INFO-TECH CITROËN Racing C2 R2 and C2 R2 MAX N° 29/10.

Subject: Engine power cut.

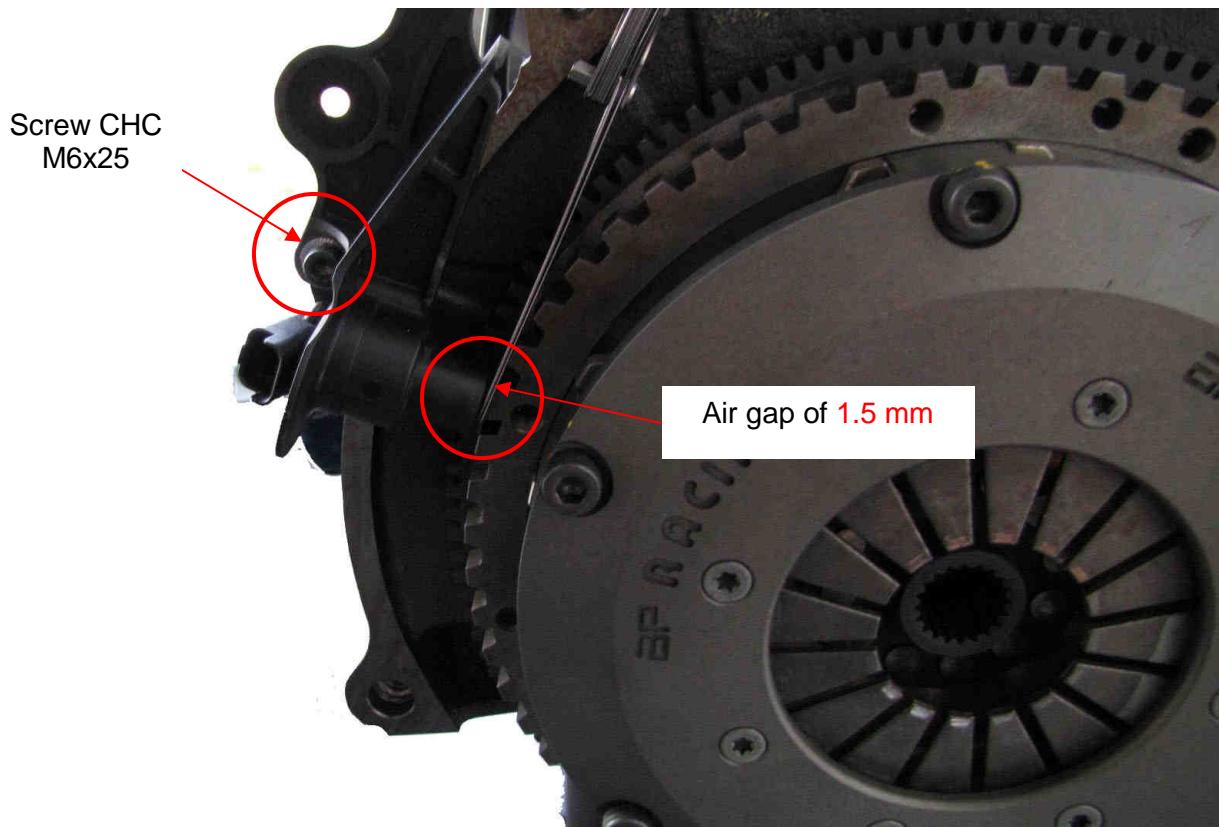
If you encounter some engine power cut on your C2R2 MAX it might be due to a default of the engine speed sensor.

In order to limit the risk of appearance of this default it is wished to modify the engine speed sensor to increase the air gap and get a stronger signal.

Modification of the distance between the engine speed sensor and the flywheel.
Original value 0.8mm

To increase this air gap, remove the locating part of the metallic insert as shown on the picture below :

Then drill the insert at **$\varnothing 7.5\text{mm}$** in order have a tuning clearance.

Fit the sensor back on the engine and replace the screw head H M6x25 by a CHC M6x25 to allow an easier tightening. Tune the air gap at **1.5mm**.
